Product Change Notification / JAON-18TQGC397

CCB 5014.001 and 6259 Final Notice: Qualification of a new die size (1.932x1.860mm) for Die #1 of selected Microsemi LE9641PQC, LE9651PQC, LE9641PQCT, and LE9651PQCT catalog part numbers (CPN) available in 48L VQFN (7x7x1.0mm) package assembled at MMT assembly site.

Pre and post change comparison

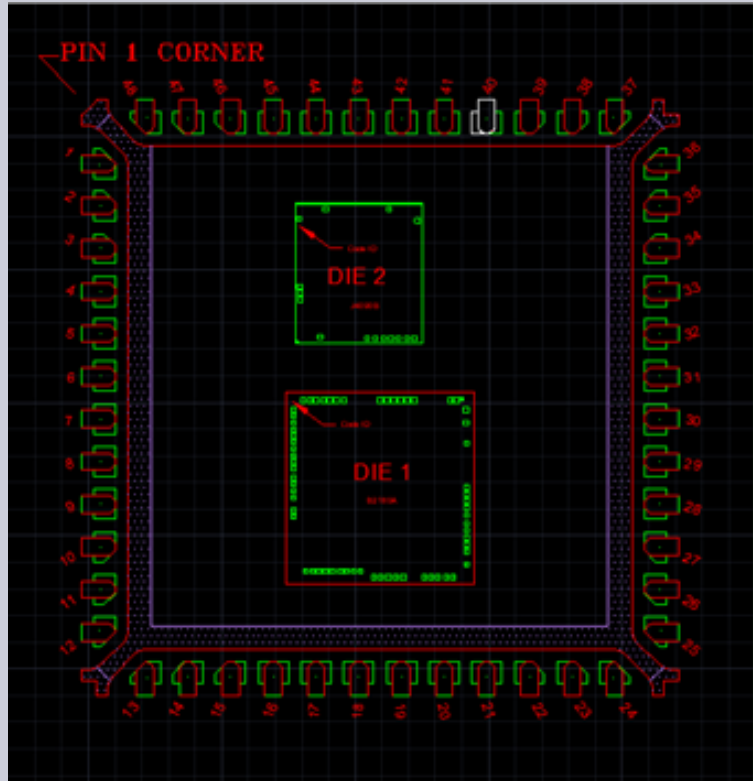
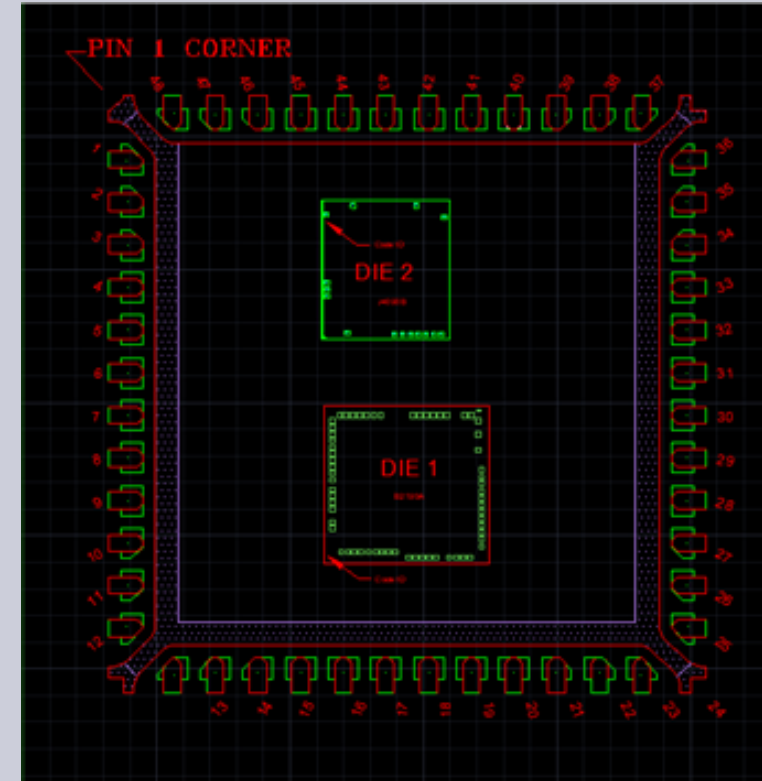
Description of Change:Qualification of a new die size (1.932x1.860mm) for Die #1 of selected Microsemi LE9641PQC, LE9651PQC, LE9641PQCT, and LE9651PQCT catalog part numbers (CPN) available in 48L VQFN (7x7x1.0mm) package assembled at MMT assembly site.

Reason for Change:To improve productivity by qualifying a new die size.
